# Town of Milford Meeting Notice

**Board or Commission: Conservation Commission**

**Date and Time of Meeting: Wednesday September 16, 2020 at 7.00 P. M**

TO: Mr. Michael Giampietro, Chairman – Conservation Commission  
FROM: Michael Dean, P.E. *MD*  
DATE: September 11, 2020  
SUBJECT: **158 East Main Street (formerly #154) – Kevin Meehan – Hyundai Dealership  
Request for Certificate of Compliance – DEP File # 223-526**

SITE DEVELOPMENT & FACILITIES PLAN  
 LOT 14 FIELD POND ROAD  
 IN  
 MILFORD, MA

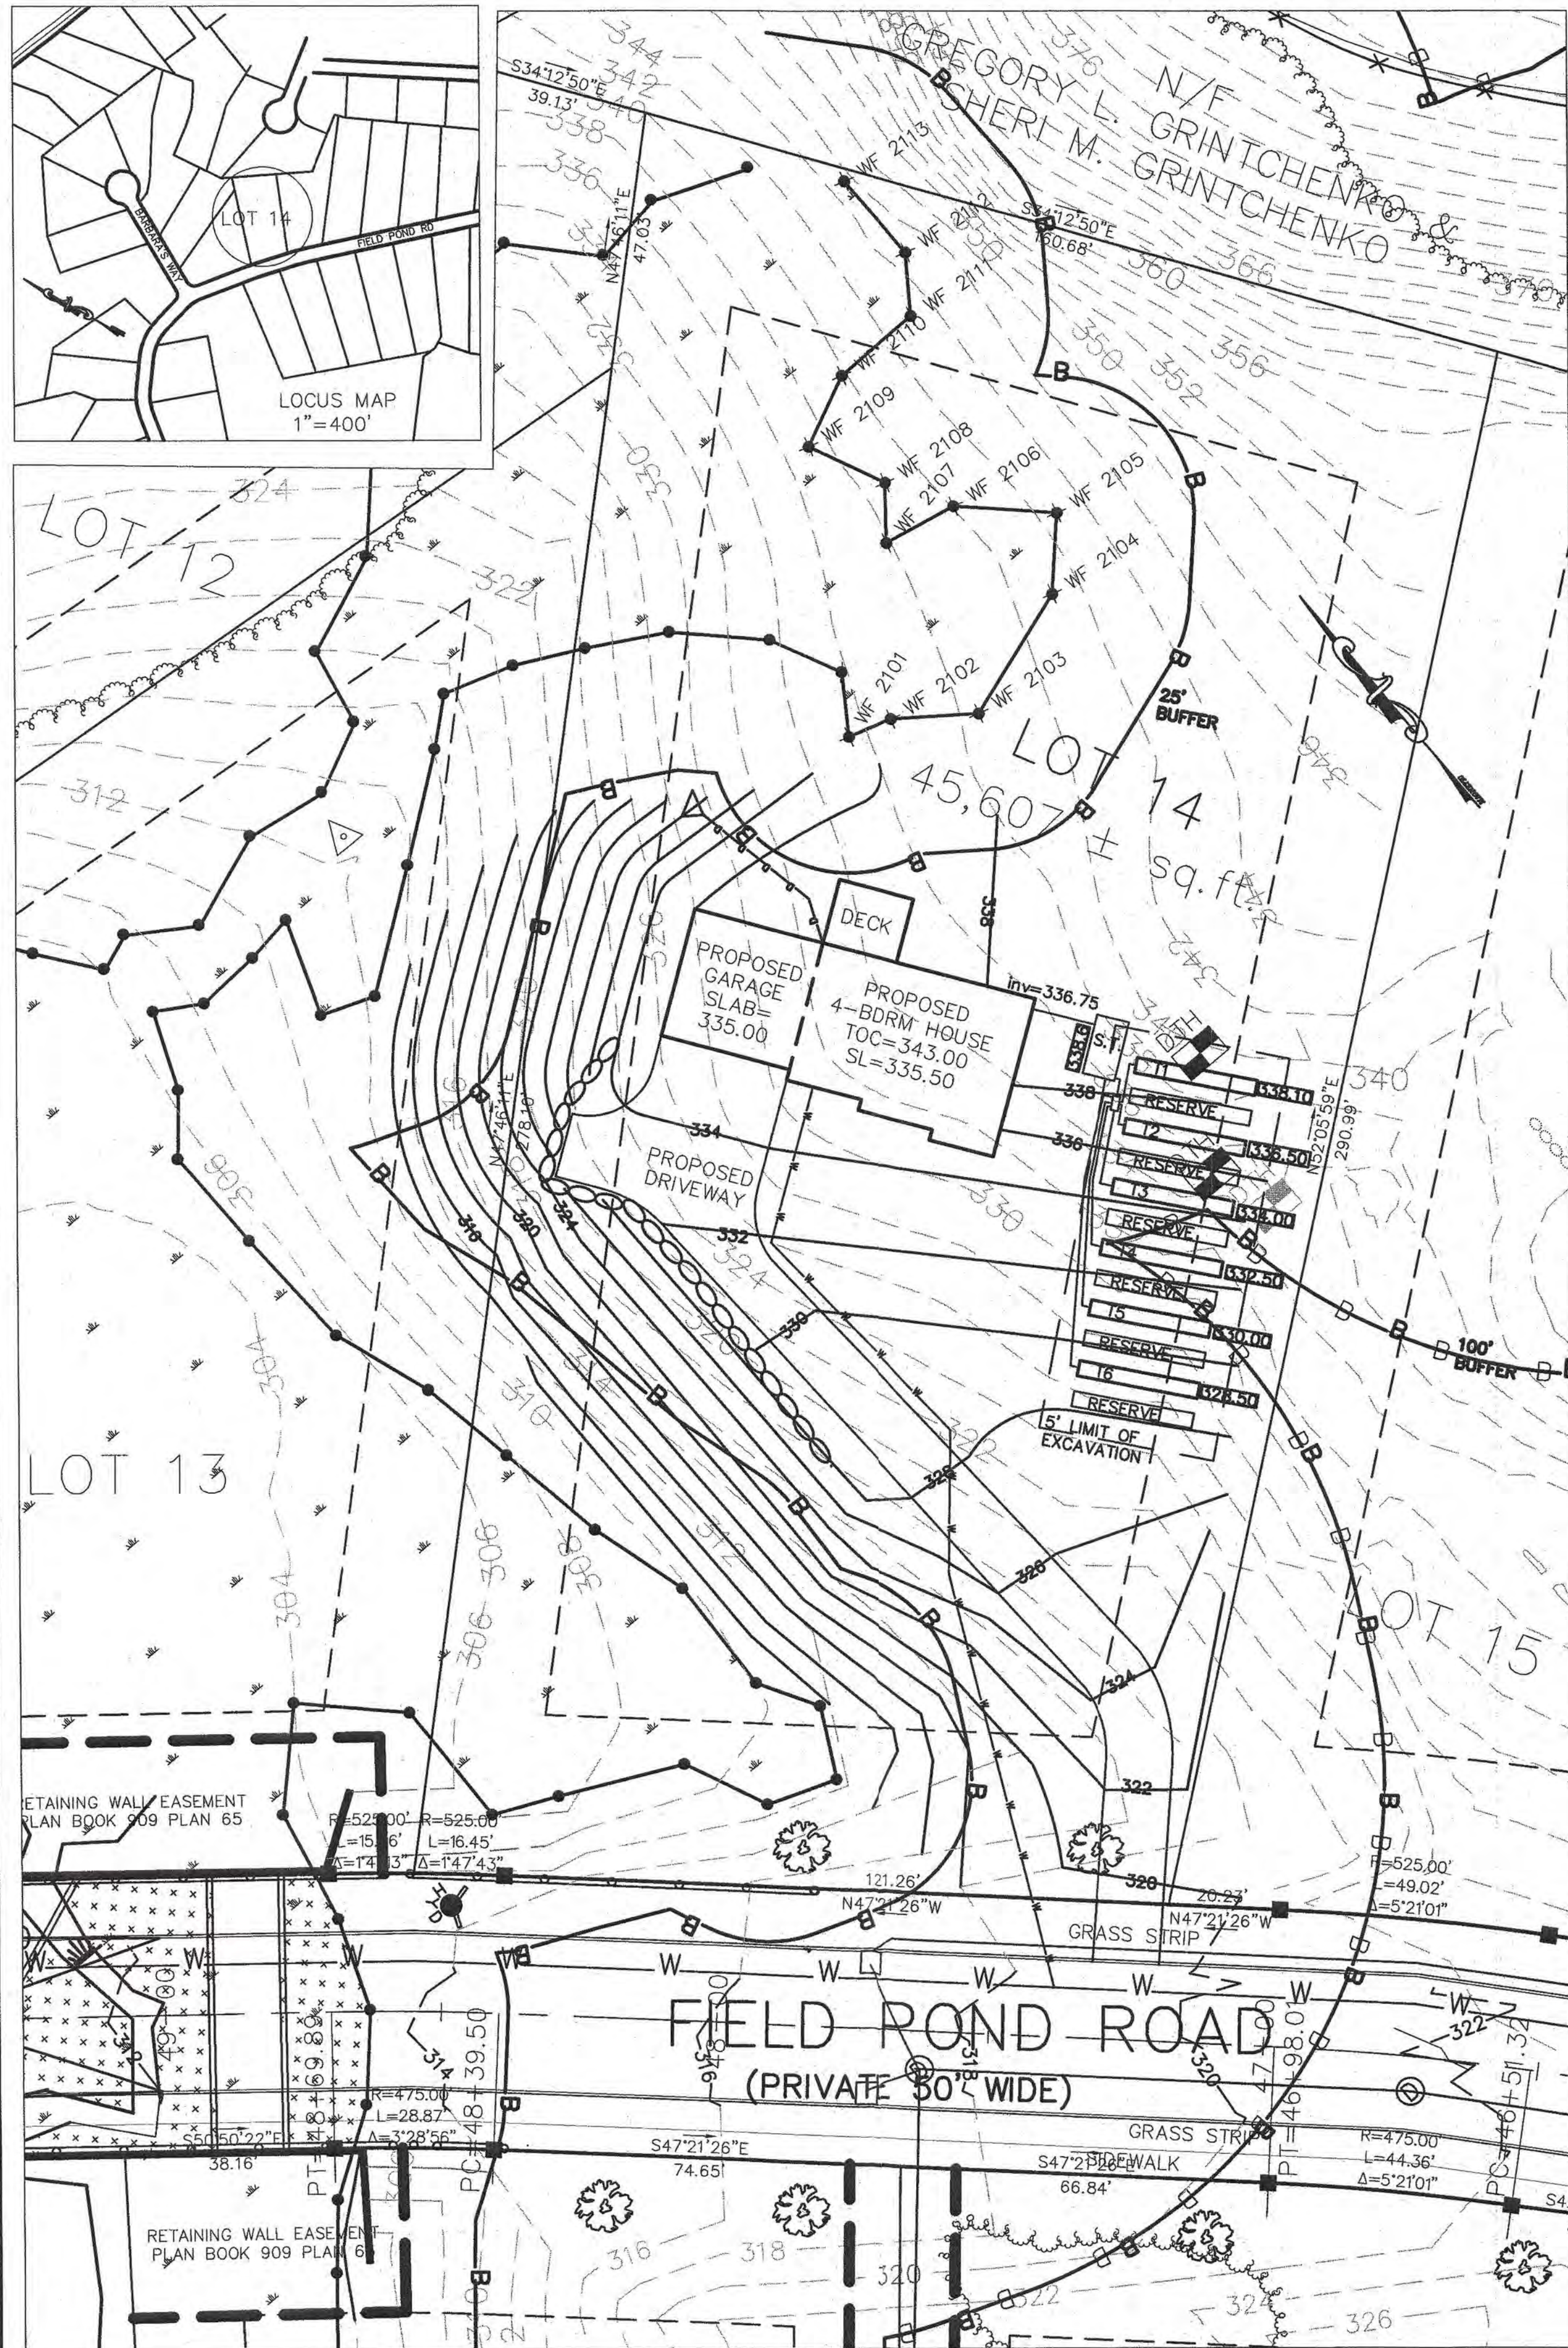
1. The trees have already been cleared, must have been due to an oversight. All the work is in the 100-foot Buffer Zone of the BVW, there is no alteration of the Resource Areas. The closest distance from the proposed activity to the edge of the wetlands is approximately 5-feet +/-.
2. Erosion control measures should be shown on the plan.
3. The wetland flag numbers are shown on some of the flags, but not all of the flags. The remaining wetland flag numbers should be added to the plan.

I recommend that the above items be added to the plan and then issue an Order of Conditions.

**SEPTIC SYSTEM DESIGN PLAN OF LAND**  
**LOT 9 GORDON DR**  
 IN  
**MILFORD, MA**  
 SCALE: 20 FEET TO AN INCH  
 DATE: AUGUST 3, 2020

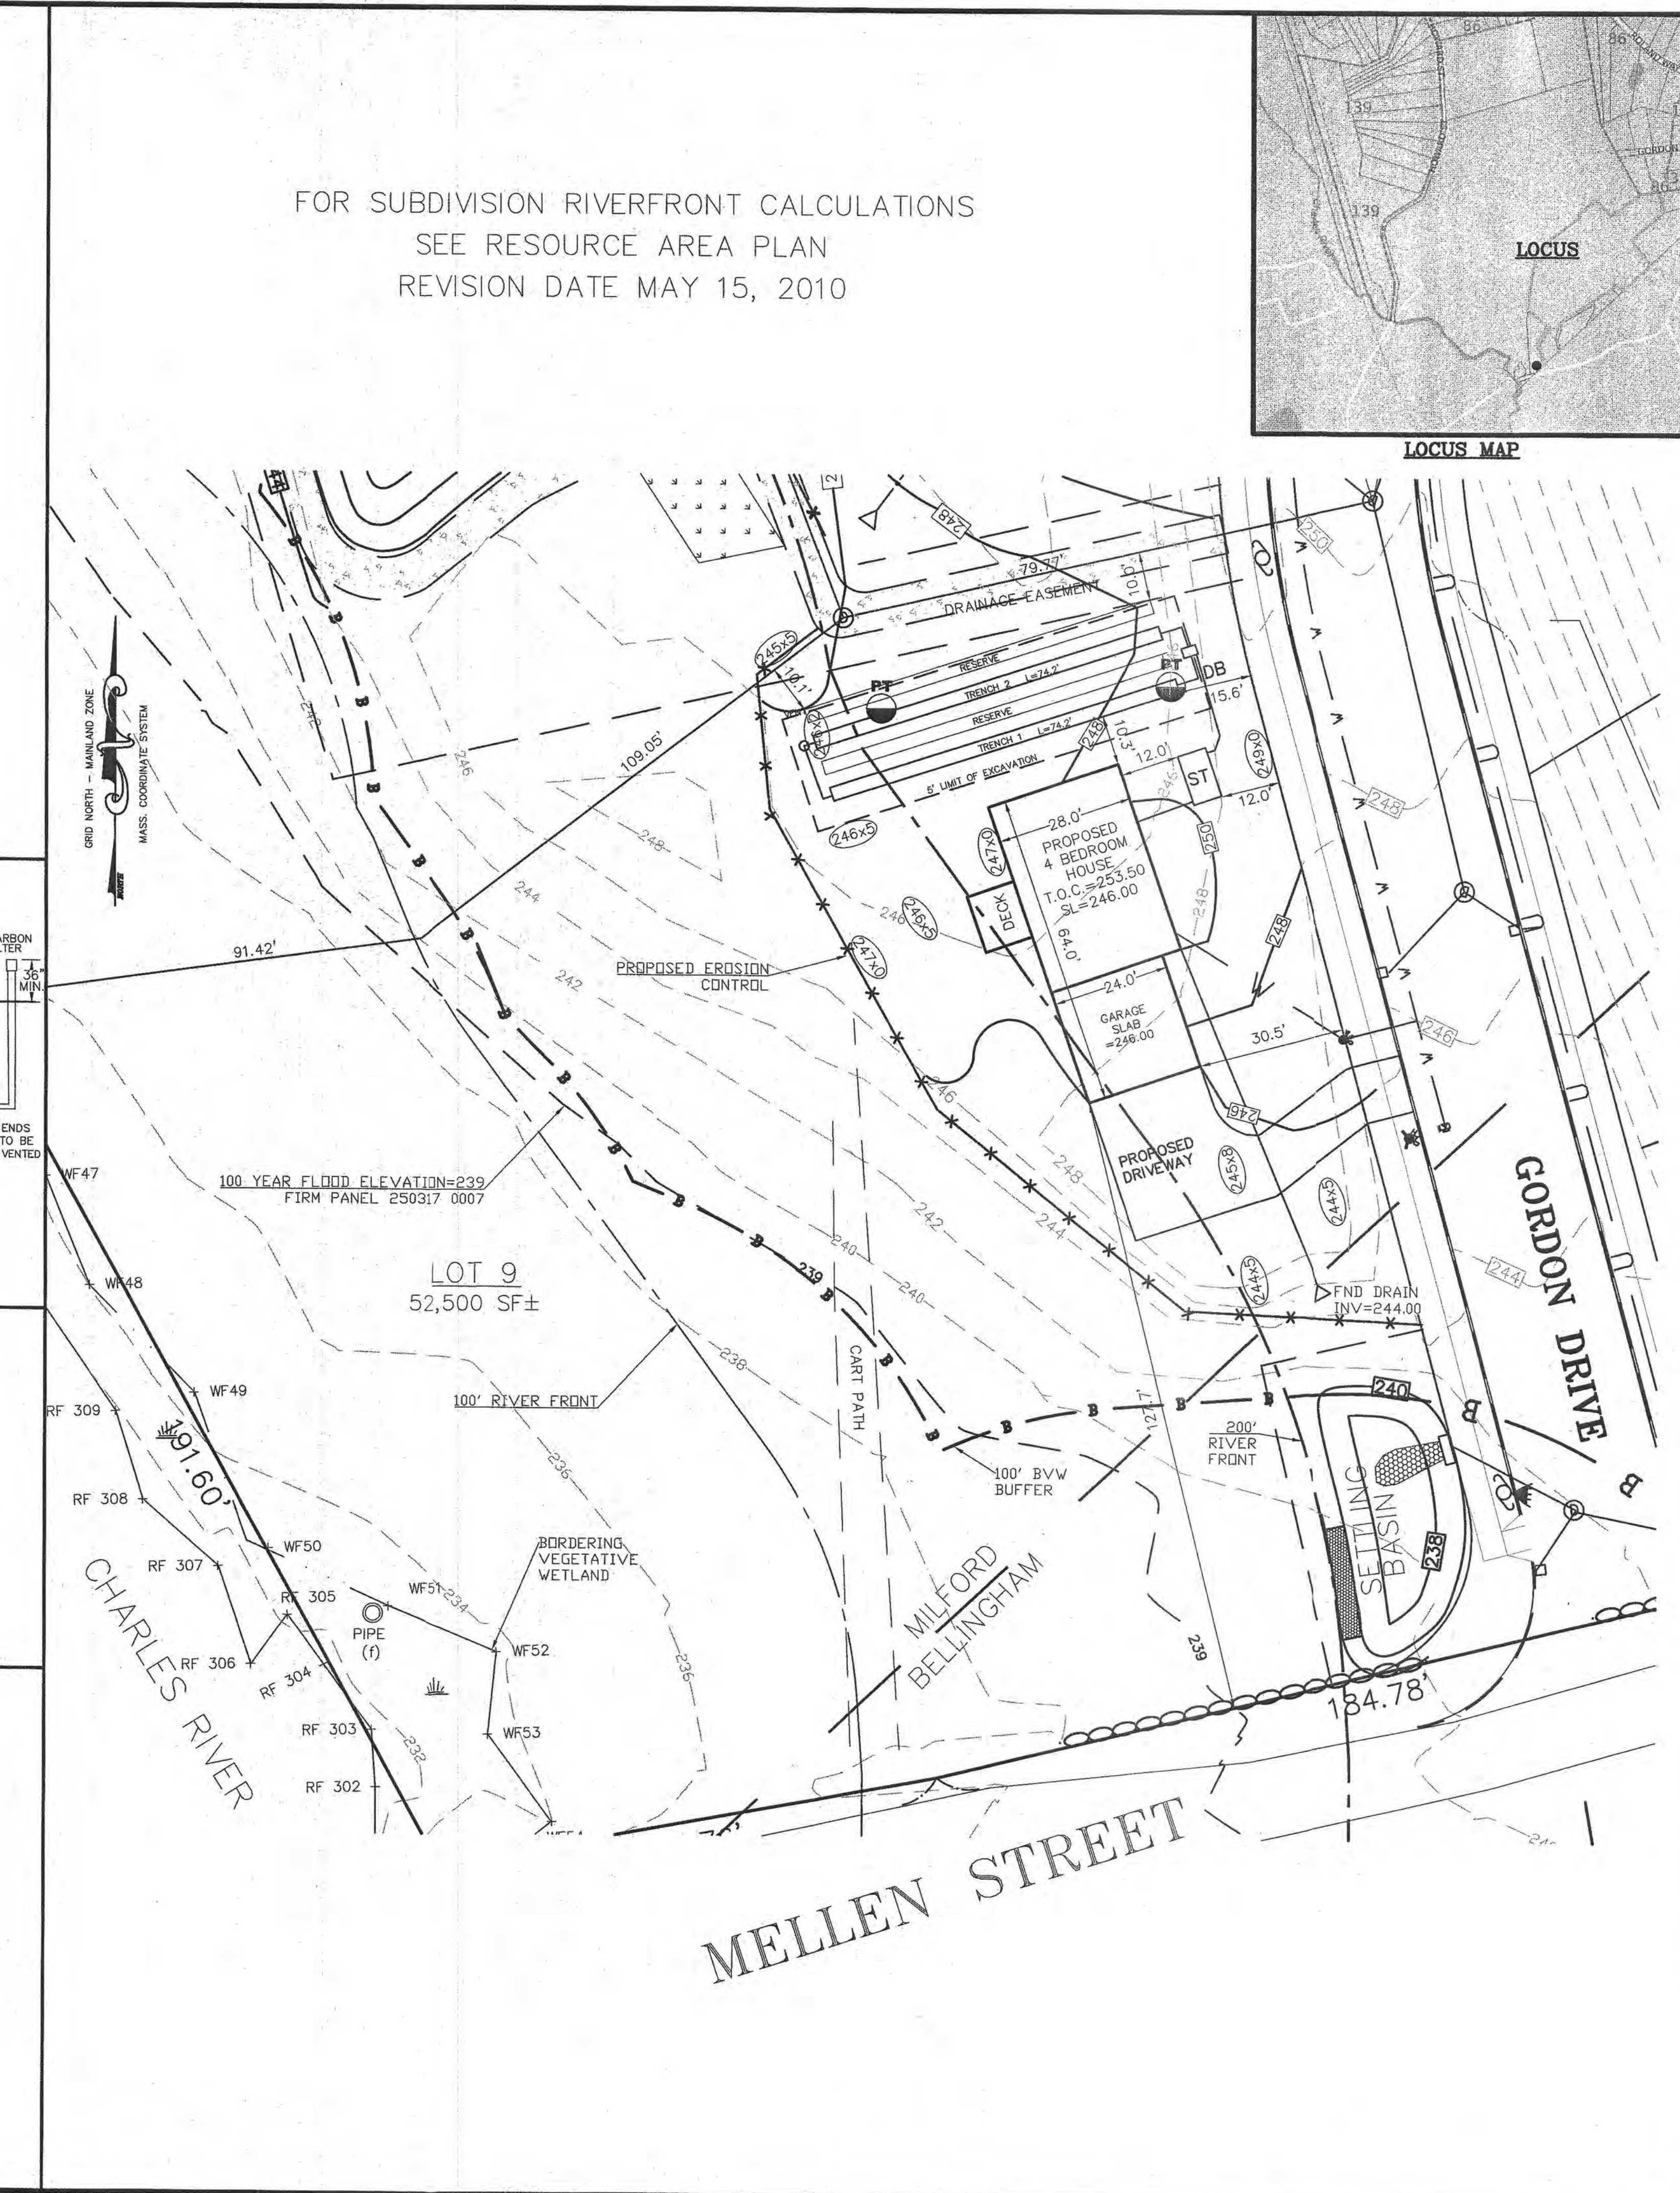
1. This recent submittal states the proposed Riverfront Area to be disturbed is 3,800 SF, for Lot 9 only. This number is reflective in the Notice of Intent / paper work, not depicted on the site plan. This exceeds the original permitted total riverfront disturbance by 3,200 SF. If approved the individual Lot filing would essentially be changing the original approval set by this Commission under the approved Order of Conditions for DEP File # 223-1016.
